Project  
**BEDFORD PASSAGE DEVELOPMENT**

Title  
**LANDSCAPE LEVELS AND SETTING OUT - SHEET 01**

Drawing No. **BPD-HLM-00-00-DR-L-00011** Revision **C17**

B1 BASEMENT LEVEL 1:100

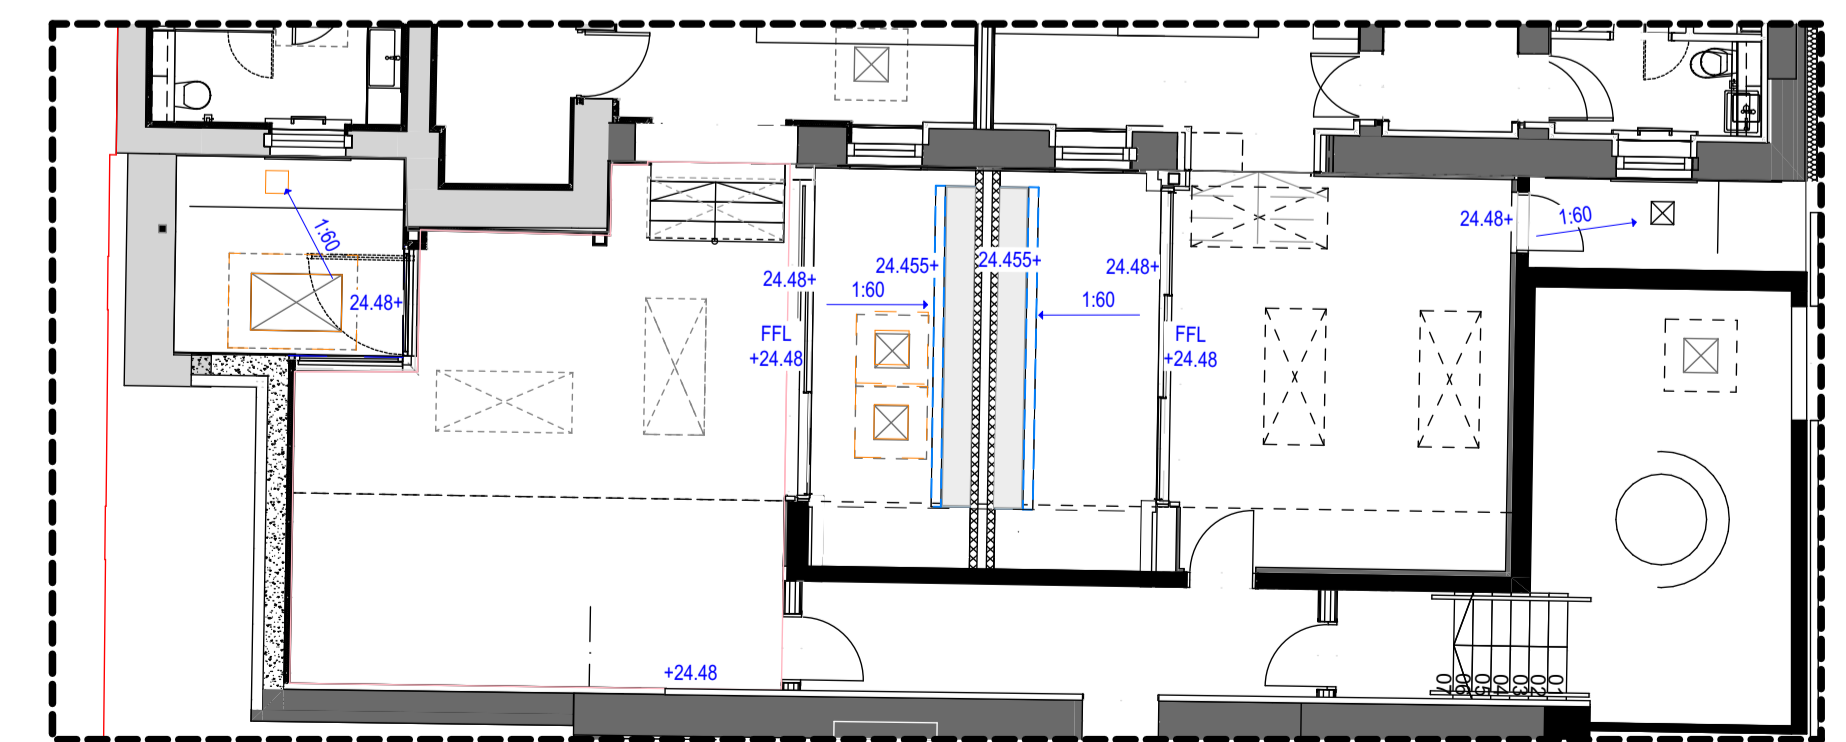
HATCHING ADDED TO EXCLUDE NEW BUILD SCOPE FROM WORKS PACKAGE

NEW BUILD WORKS BY OTHERS
